Project No. 2021\_154

MIDLOTHIAN ISD STADIUM ADDITIONS AND RENOVATIONS

ADDENDUM NO. 2

DATE: October 18, 2021

4 STOREFRONT SILL AT FOUNDATION  
3" = 1'-0" REF 2 / A-303

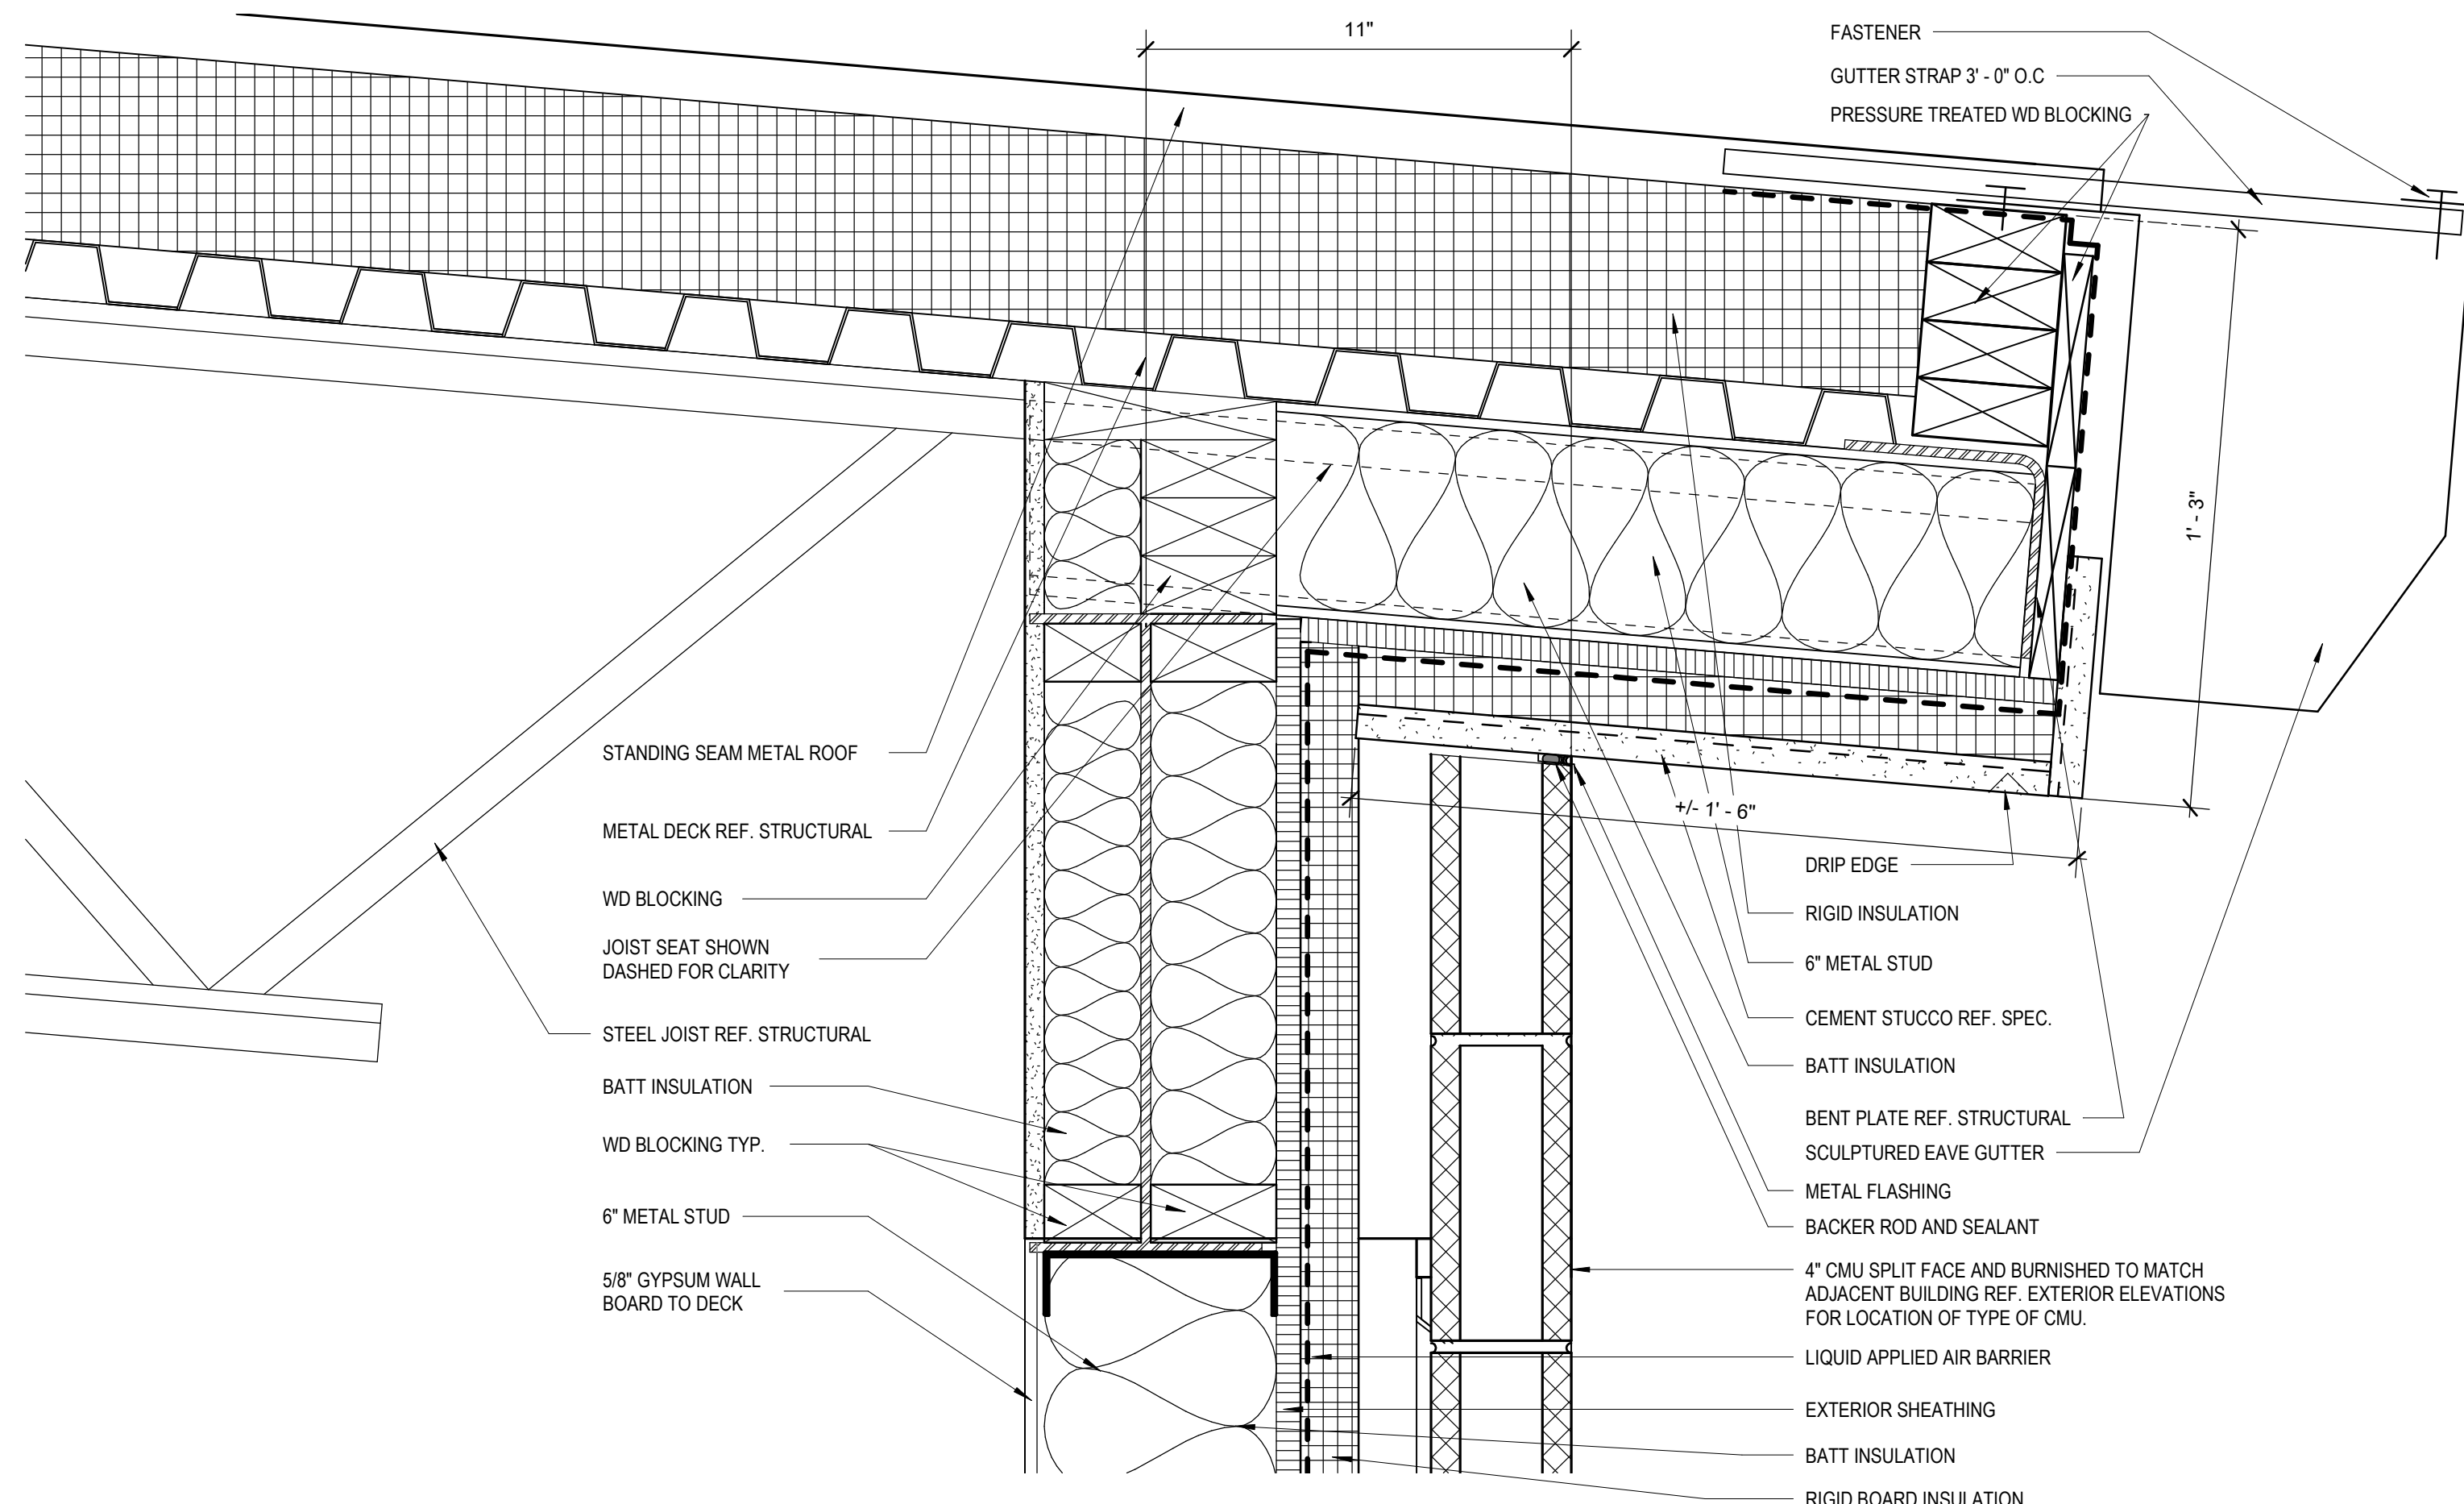
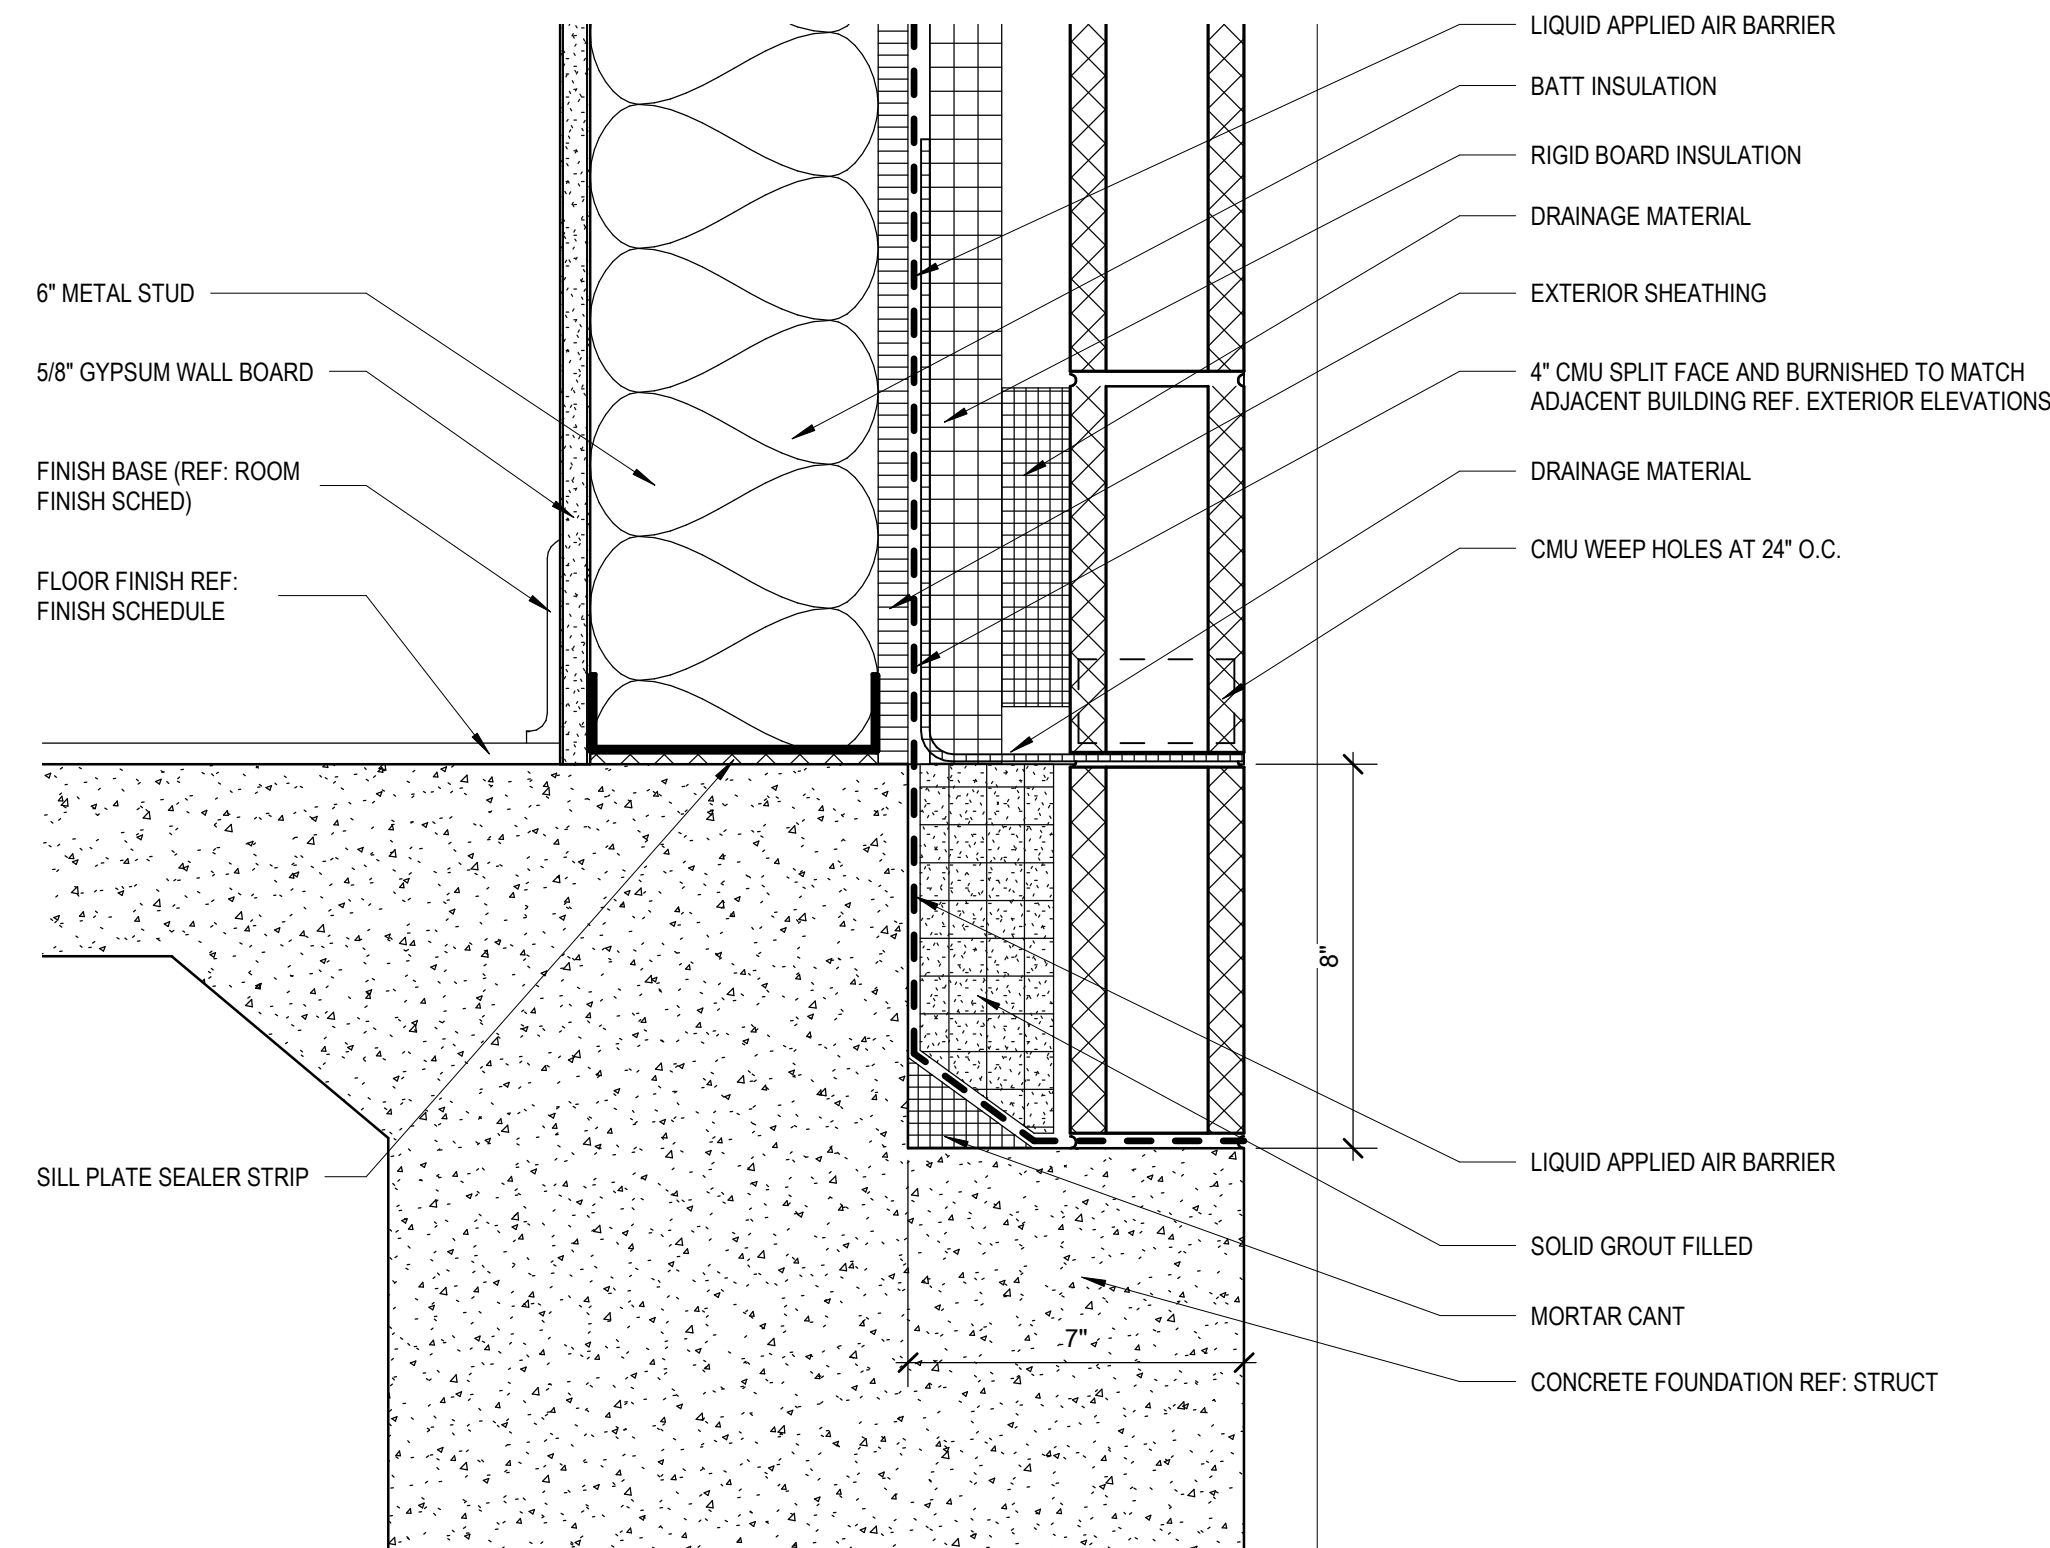
- a. REVISED structural tube beam to correct location per structural.
